FINAL PLAT

PIZZA HUT PAWNEE/HYDRAULIC ADDITION

RE: SUB 2000-60 -- One-Step Final Plat of PIZZA HUT PAWNEE/HYDRAULIC ADDITION

STAFF REPORT

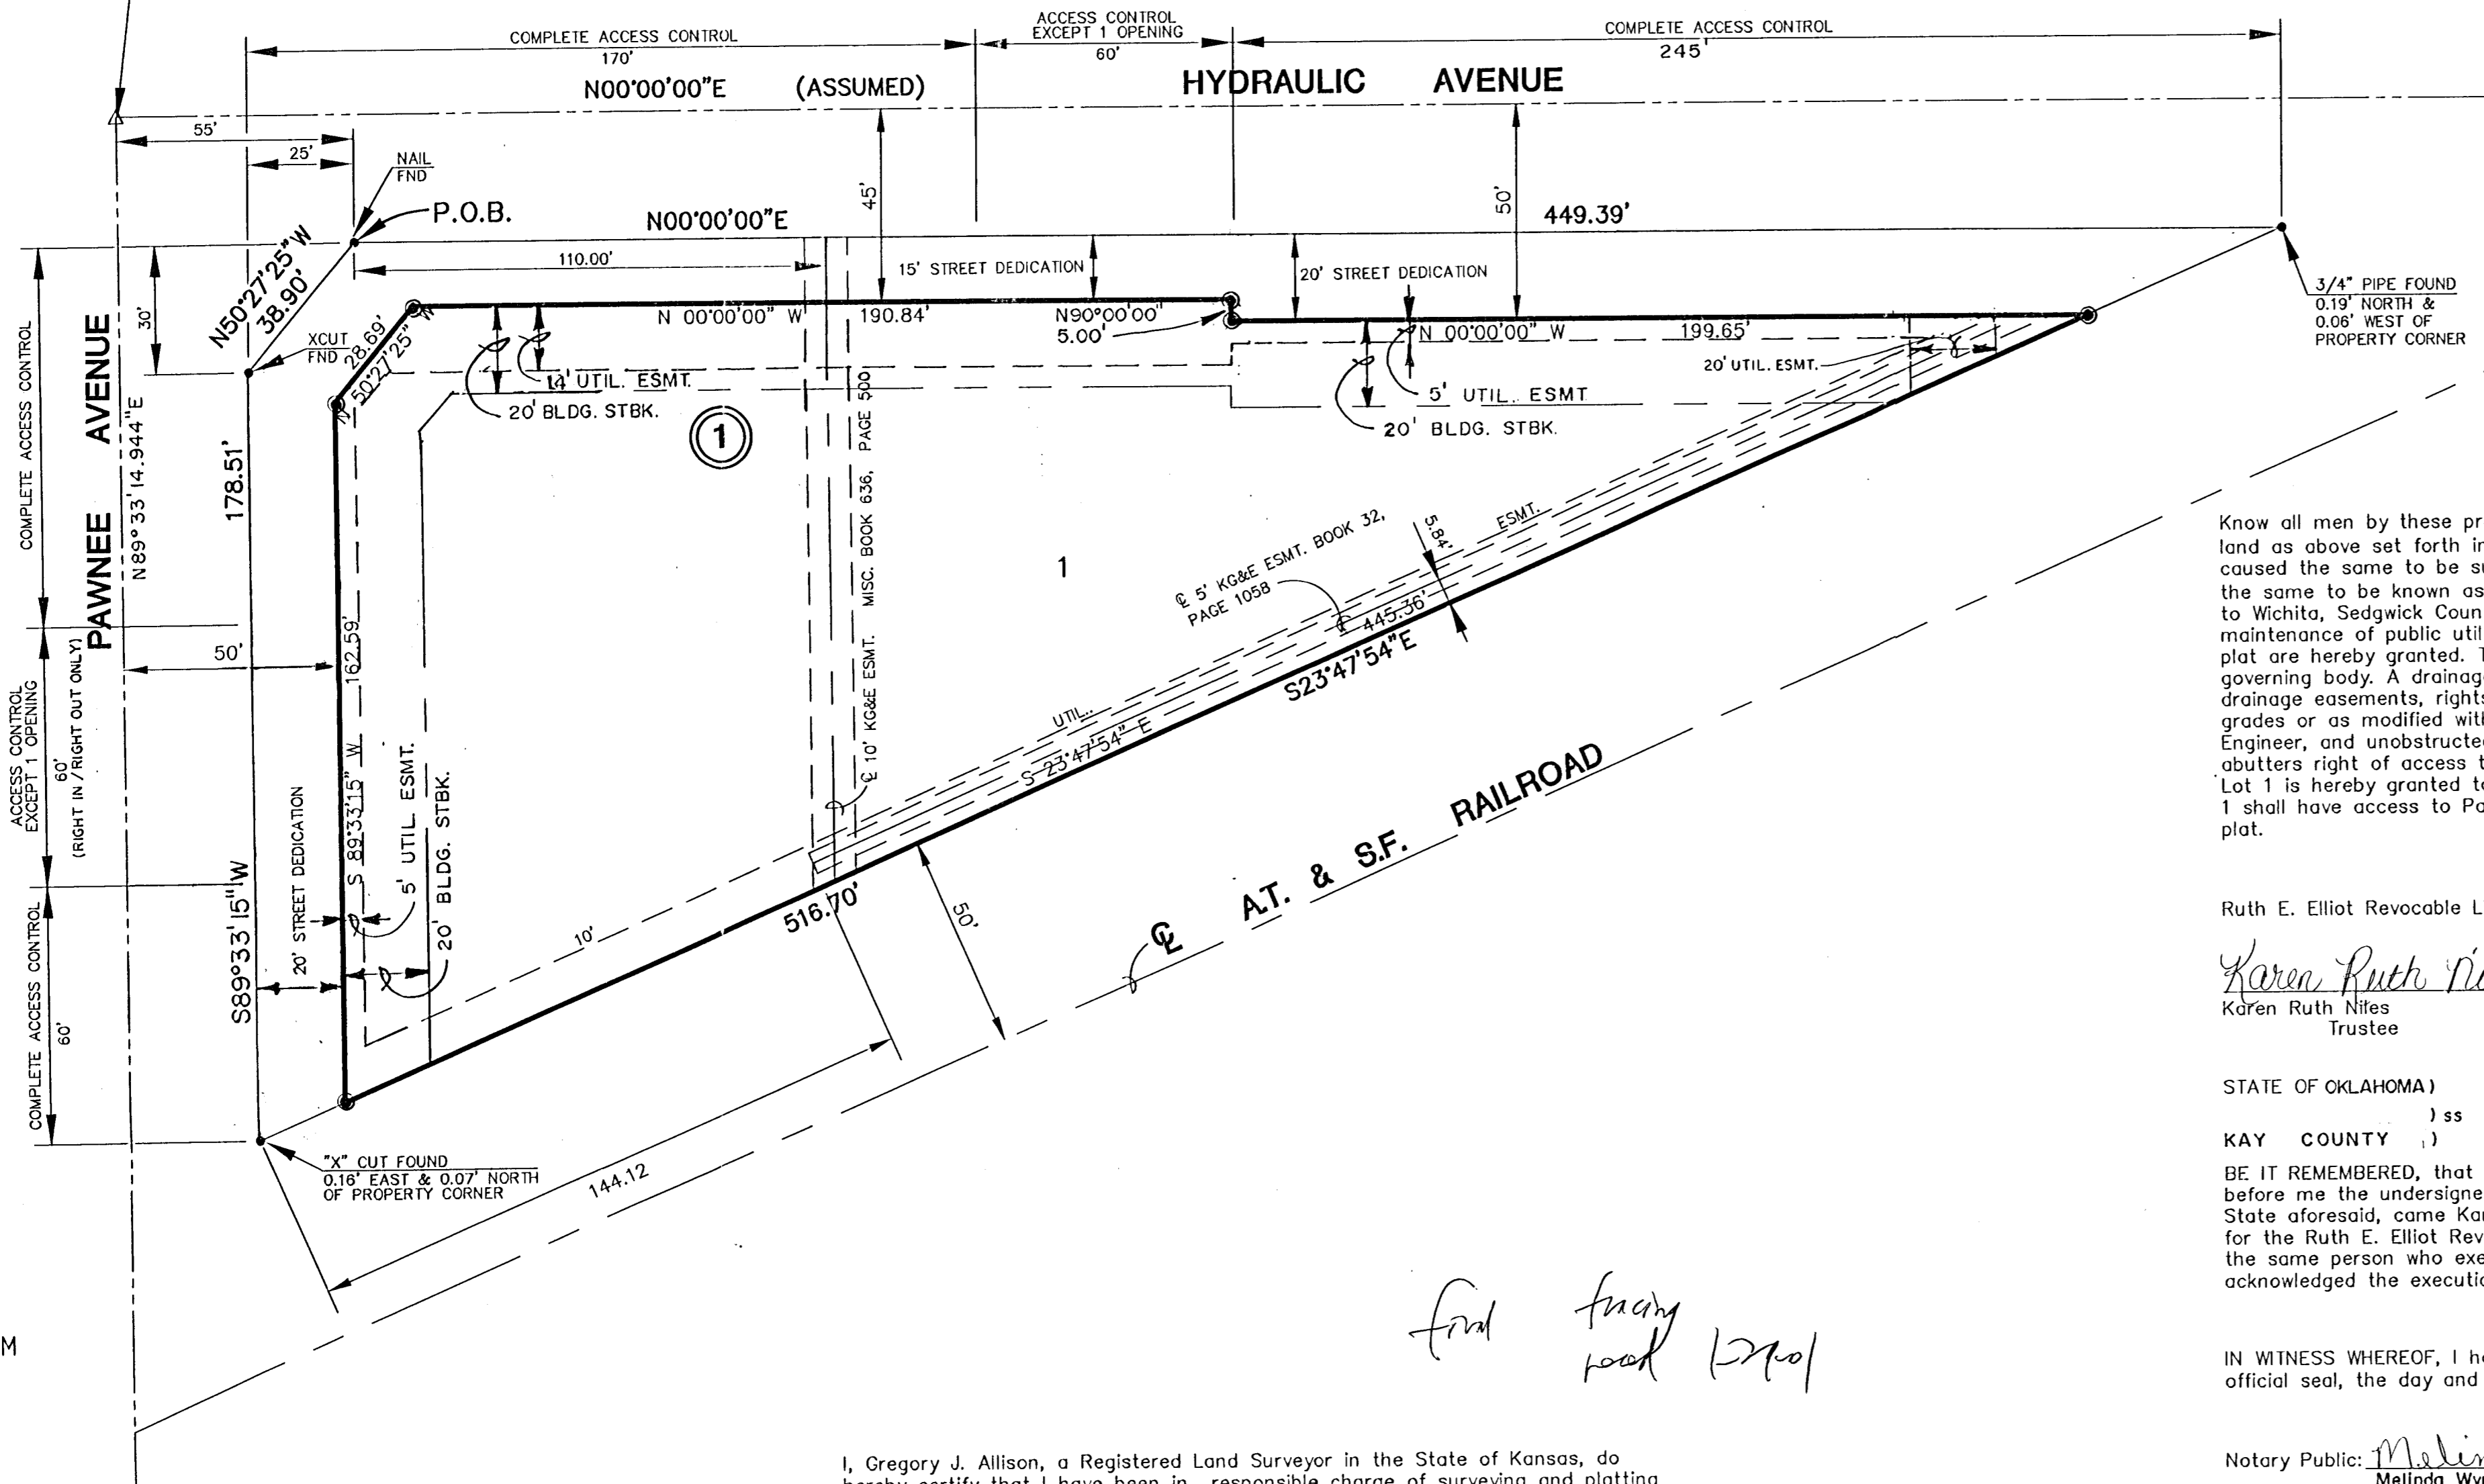
- A. Municipal water and sanitary sewer services are available to serve the site. City Engineering needs to comment on the need for any guarantees or easements. *A 20-ft wide easement will need to be platted to cover the existing east-west sanitary sewer line across the northern portion of the site. A temporary easement is needed to cover the sewer line running parallel with the east line of the plat until its removal.*

- D. City Engineering needs to comment on the status of the applicant's drainage plan. *A revised drainage plan needs to be submitted. As some of the site's drainage is directed onto the adjacent railroad right-of-way, a letter shall be provided from that railroad indicating their willingness to accept such drainage.*

- E. Traffic Engineering needs to comment on the access controls. The plat proposes three access openings along Hydraulic and two access openings along Pawnee. 150 feet of complete access control is required from the intersection and from the nearest railroad track. This will necessitate a modification from the Subdivision Committee. Distances should be shown for all segments of access control. The final plat tracing shall reference the access controls in the plat's text. *Traffic Engineering has approved one opening along Hydraulic (full turning movements) and one opening along Pawnee (right turns only). The Subdivision Committee has approved a modification of the required complete access control along Pawnee.*

- F. **Traffic Engineering** needs to comment on the need for additional right-of-way along Hydraulic and Pawnee. *The Applicant shall dedicate 50-ft of half street right-of-way along the northern 245 feet of the plat's frontage along Hydraulic, 45-ft of half-street right-of-way along the remainder of Hydraulic, 50 feet of half-street right-of-way along the corner clip, and 50 feet of half street right-of-way along Pawnee.*

- G. The platting binder shows that the site's ownership is in the name of additional parties. These names must appear on the owner's signature block on the final plat tracing.

- H. The owner's name "Noles" on the signature block needs to be corrected to "Niles" as referenced in the platting binder.
- I. The Deputy County Surveyor has advised that the plat boundary does not close.

- J. The "utility setback" along the south needs changed to a "utility easement".
- K. The width of the KGE easement in Book 32, Page 1058 needs to be denoted, along with the location of the south end of the easement.

- L. On the Benchmark, both C's need changed to Centerline.
- M. The legend needs changed from "=I.P." to "=found monument".
- N. Based upon the platting binder, property taxes are still outstanding. Before the plat is scheduled for City Council consideration, proof shall be provided indicating that all applicable property taxes have been paid.

- W. The representatives from the utility companies should be prepared to comment on the need for any additional utility easements to be platted on this property. Southwestern Bell requests a 10-ft utility easement along the eastern line of the plat.
